## ZONING CHANGE REVIEW SHEET

CASE: C14-2022-0140

**Project Name and Proposed Use:** C14-2022-0140, 5401-5403 Clay Ave. and 5402-5408 Wm. Holland Ave. Project: Brentwood Multifamily. 2.4412 from CS-MU-V-CO-NP and MF-3-NP to CS-MU-V-CO-NP and MF-6-NP. Vertical Mixed 350 unit multifamily project, with 12 percent of the VMU zoned units as income-restricted affordable housing for households earning up to 60 percent of Median Family Income

**To:** Kathy Smith, P.E., PTOE (HDR)  
**CC:** Renee Johns, AICP; Maria Cardenas  
**FROM:** Nathan Aubert, P.E.  
**DATE:** February 13, 2023  
**SUBJECT:** Brentwood Multifamily NTA (C14-2022-0140)

**FIGURE 1**  
SIDEWALK CONSTRUCTION LOCATIONS

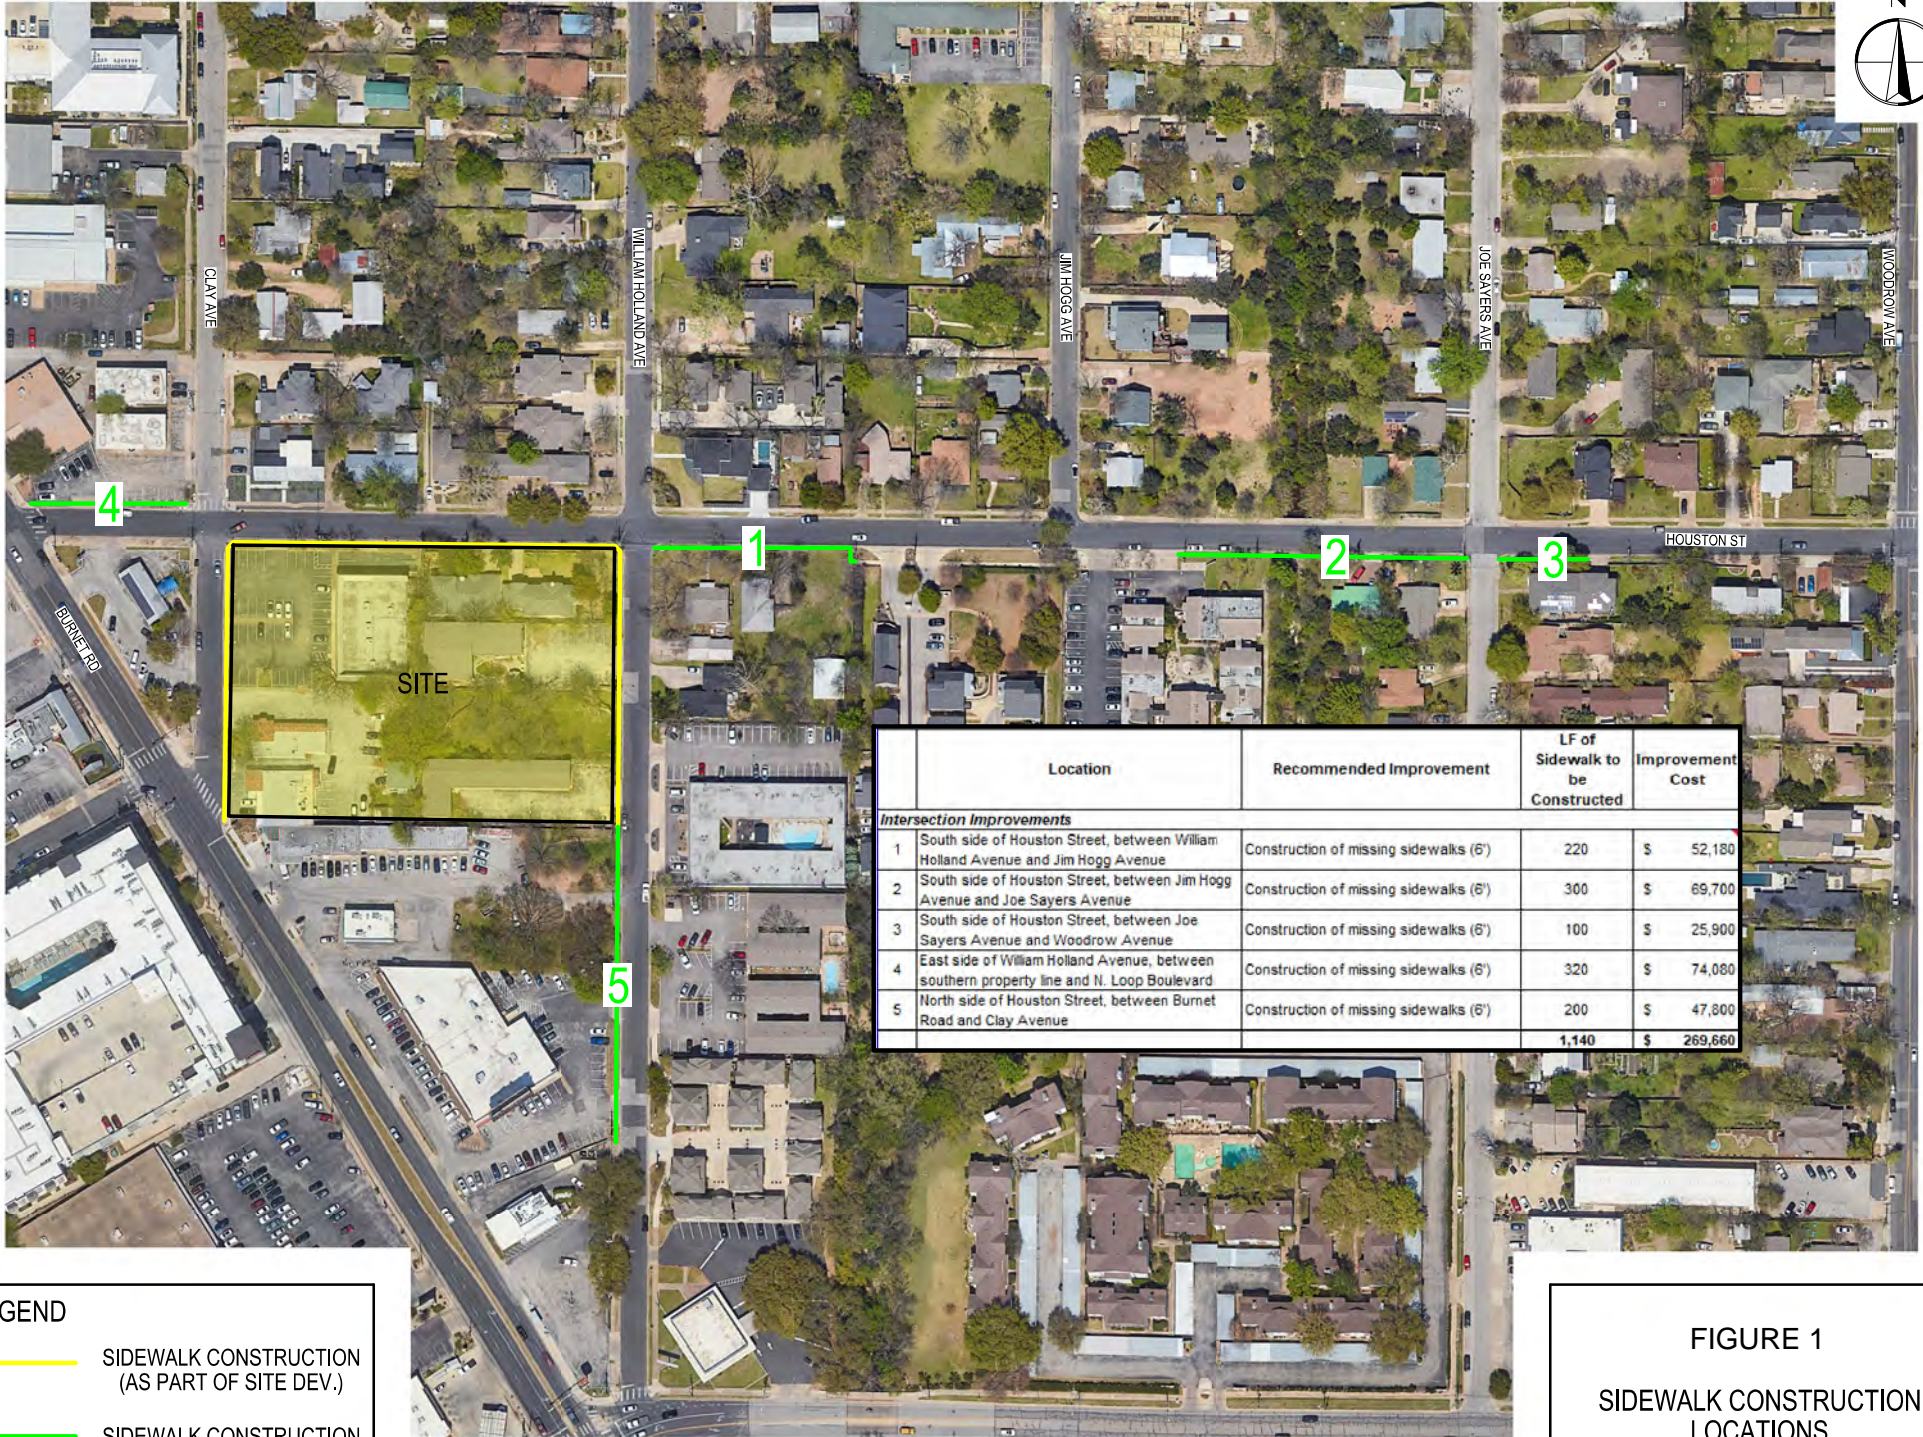
1. Houston Street, Clay Avenue and William Holland Avenue all have sidewalk gaps in the vicinity of the site. At time of site plan, this development will be required to complete gaps in the sidewalk network to adhere to ASMP standards. See Figure 1 for sidewalk construction locations proposed by the applicant.

The site development permit for the above noted site shall not be released until the improvements are shown in the site plan. Please contact me at (512) 974-7136 if you have questions or require additional information.
